**PARK CITY HISTORIC PRESERVATION BOARD MEETING
SUMMIT COUNTY, UTAH
June 4, 2025**

Subject: 176 Main Street
Application: PL-25-06472
Author: Meredith Covey, Planner I
Date: June 4, 2025
Type of Item: Deconstruction, Reconstruction, and Material Deconstruction

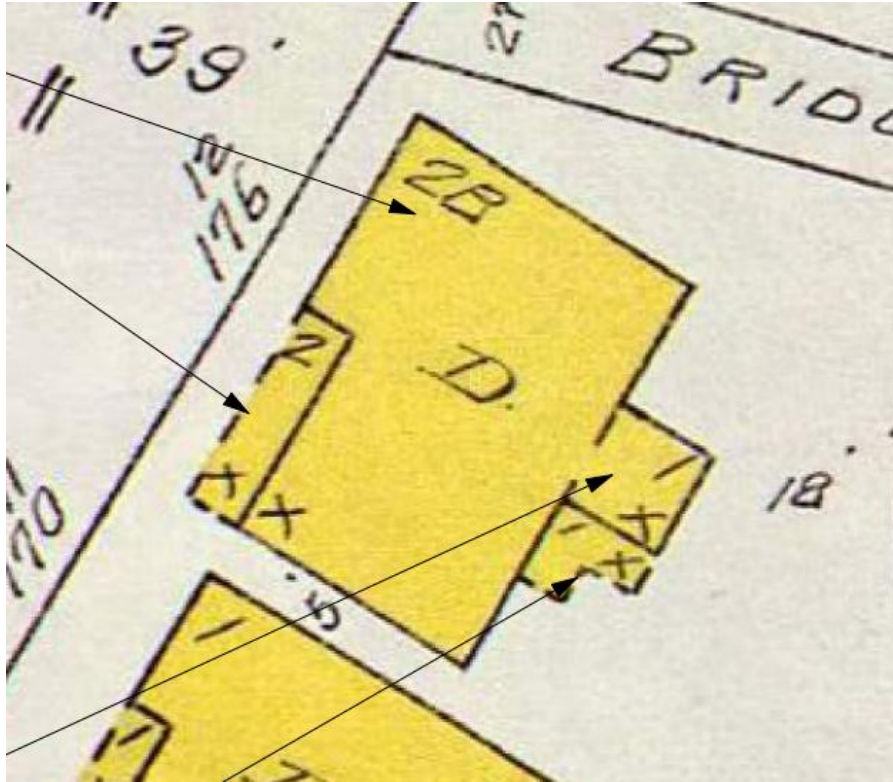
(2) The Historic Structure cannot be made safe and/or serviceable through repair.

The Applicant submitted a report from a licensed structural engineer concluding the Structure cannot be made safe and/or serviceable through repair (Exhibit E – Structural

Engineer Report). Staff also finds the Historic Structure—except for the potential of panelizing the secondary (north) façade—cannot be made safe and/or serviceable through repair. Additionally, the Applicant has provided scans of the Structure (Exhibit I) that show the shift in the walls, floors, and roofs of the Structure. The scans show the degree to which the walls are leaning and the sloping of the roof.

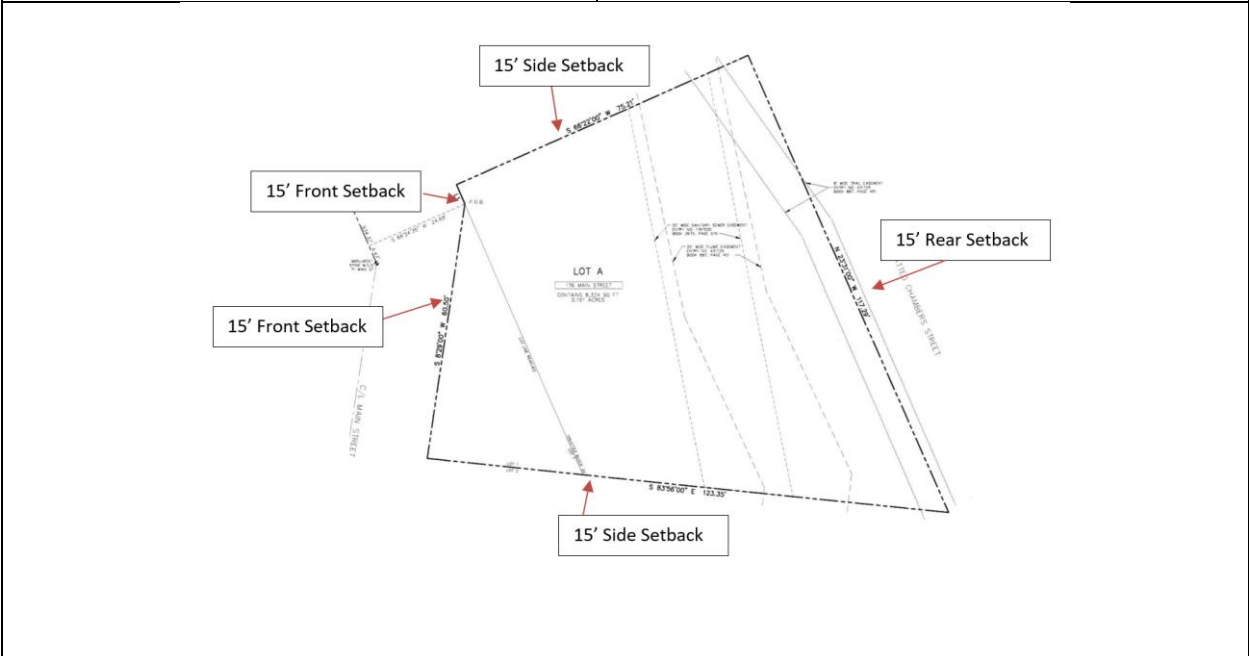
Site Design	
Building Setbacks Maintain the existing front and side yard setbacks of Historic Sites.	Complies: According to LMC § 15-4-17 , the Planning Director determines Setbacks for Lots with more than four sides. 176 Main Street is a five-sided Lot and the Setbacks for this Site

The Landmark Historic Structure encroaches in the Front Setback by 12 feet. However, pursuant to LMC [§ 15-2.3-4](#), existing Historic Structures that do not comply with current code are valid Non-Complying Structures. The Applicant proposes to Reconstruct the Landmark Historic Structure in the same location indicated on the Existing Conditions Survey (Exhibit K).

Any additions are required to be compliant with the Setbacks established in LMC Chapter [15-2.3](#).

Mechanical Equipment

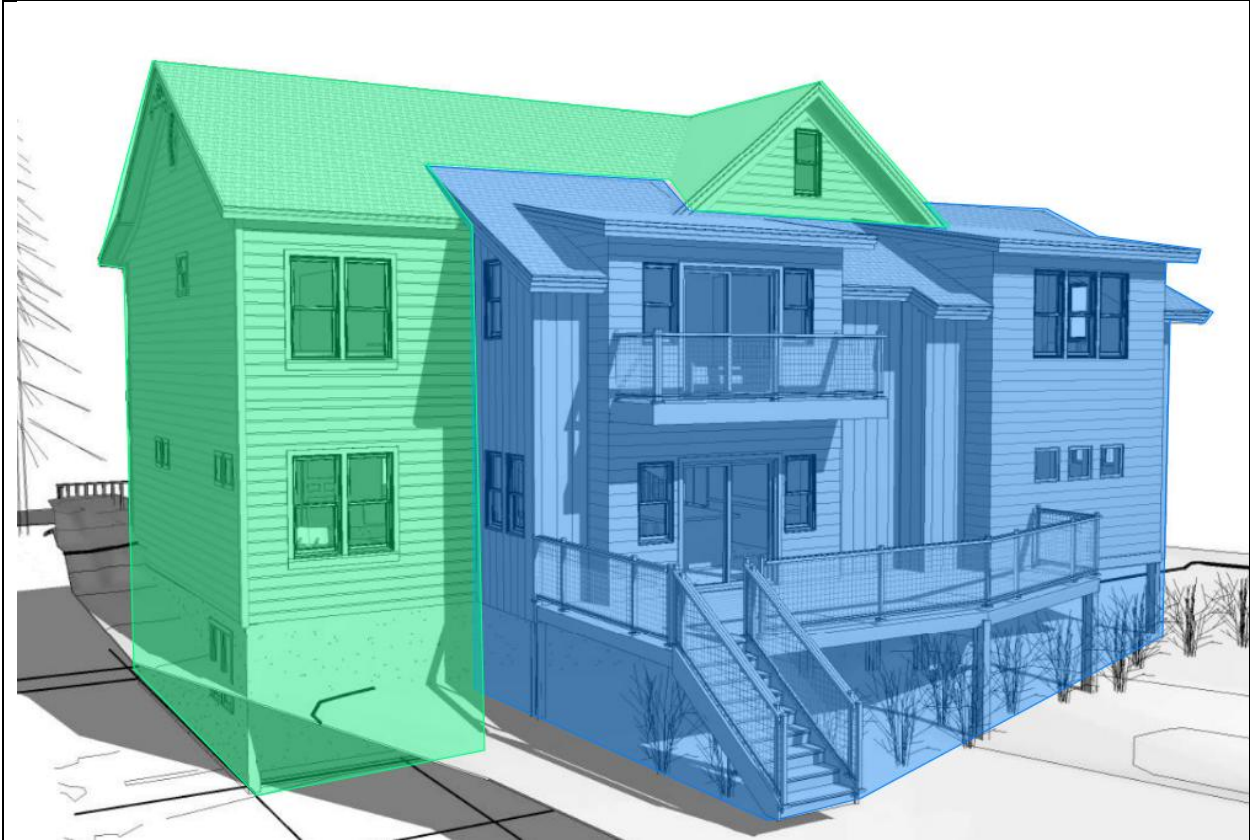
Mechanical equipment and utilities, including heating and air conditioning units, meters, and exposed pipes, shall be located on the tertiary façade or another inconspicuous location. If located on a secondary façade, it shall be screened from view by incorporating it into the appearance as an element of the design.

Condition of Approval Recommended:

Figure provided by the Applicant showing the material proposed to be removed to construct the addition.

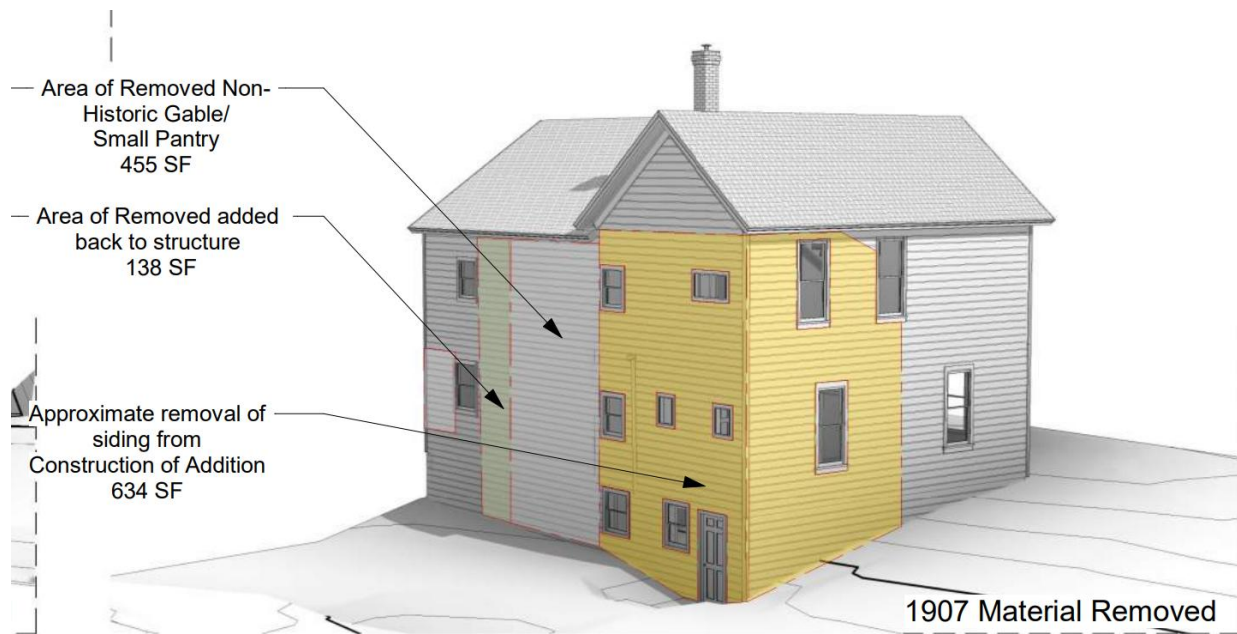
(III) The Applicant proposes to remove 634 square feet of Historic materials from the rear (north) façade in order to construct the new addition.

Pursuant to LMC § [15-11-12.5](#) the HPB reviews any requests any removal of Historic material to accommodate new additions. The Applicant proposes removing 634 square feet of Historic siding material to construct the rear addition. The Applicant proposes removing 496 square feet of non-Historic Siding to construct the addition and salvaging 138 square feet of Historic material to be reused on the Structure. The Applicant provided a plan outlining the material proposed to be salvaged and integrated into the Landmark Historic Structure (Exhibit D).

As provided in the above Analysis Section I Subsection 3 Staff recommends Conditions of Approval which require that the Applicant take careful steps to document, remove, preserve, and restore the Historic materials proposed to be removed from the Structure. Additional Staff recommends that Condition of Approval 15 be added to require that the Applicant submit an Industrial Hygienist Report that will be used to analyze the materials on the rear (north) façade can be panelized to preserve as many Historic materials as possible.
